TECHNICAL SERVICE BULLETIN

Classification: HA22-003A	Reference: NTB22-023A	Date: July 12, 2022
------------------------------	--------------------------	------------------------

BLOWER MOTOR MAKES CLICKING NOISE DUE TO SNOW INTRUSION

APPLIED VEHICLES: 2021 Rogue (T33)
APPLIED ENGINES: PR25DD

Figure 1

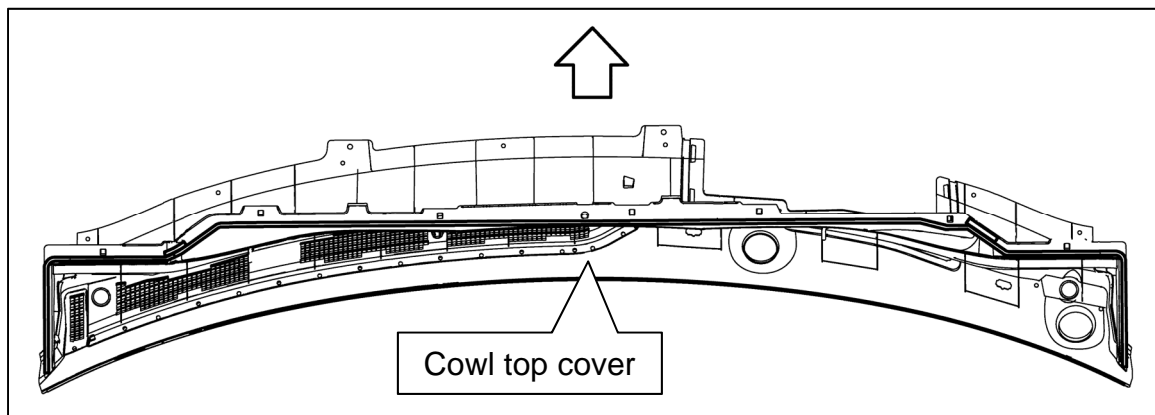
A clicking noise is heard coming from the HVAC case while the blower is operating,

Snow and/or ice is found in the HVAC blower motor case.

Replace the cowl top cover with one in the **PARTS INFORMATION**.
